## PRODUCT CHANGE NOTIFICATION

**Product Identification:** Bel 0863, 0864, 0873 2x4, 2x6, 2x8 ICMs

**PCN Number:** PC2190135

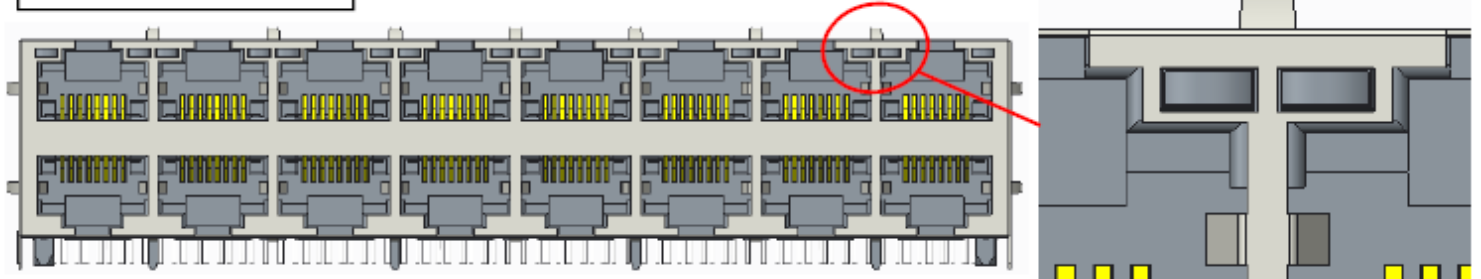
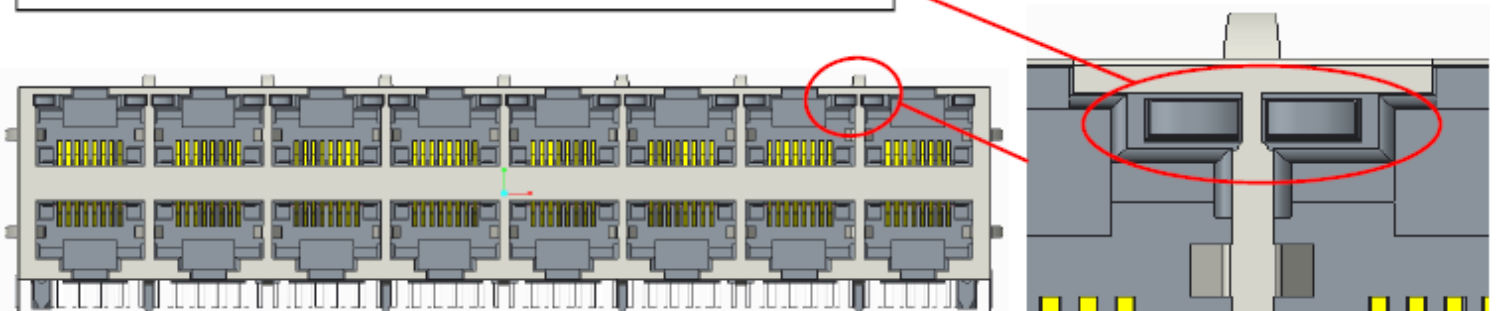
**Reason for Change (s):** In an effort to continually improve our product, Bel is pleased to announce a modification to the front shield of the 0863, 0864 and 0873 2xN ICMs in the specific area of the light-pipe and front shield. As shown below the gap between the light-pipe and shield is too small and can cause the shield to bend or become misaligned and create a snagging hazard. The solution is to remove the thin window frames from around the inside and bottom of the light-pipe.

**Description of the Change (s):** To resolve the assembly issue and deformation of the shield around the light-pipe, the thin, shield window frames around the inside and bottom of the light-pipe will be removed. By removing these thin metal pieces, the limited gap issue will be resolved and there will not be a concern for shield deformation. Please see the details below.

Old finished goods

New finished goods: remove the LED window features.
